# GRIFFEY ENGINEERING, INC.

September 7, 2025  
Mission Rise Phase 1 Construction Plan  
Engineering Review Comments  
Page 1

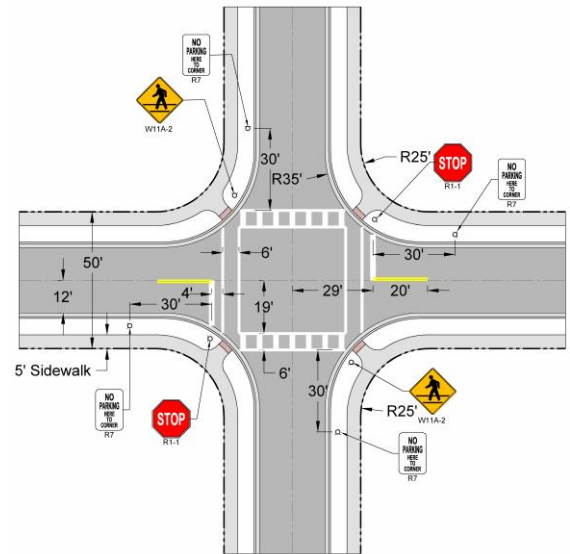
12. The intersections of the residential streets need to provide full pedestrian accommodation. Pedestrians need to have clearly designated means (crosswalks & signage) to safely traverse an intersection from any corner to any other corner or side. Intersection design needs to meet that intent and comply as much as possible with the town's road detail R1A (shown). Provide additional crosswalks at the locations shown on the attached striping markup. Include the signage as shown in R1A.
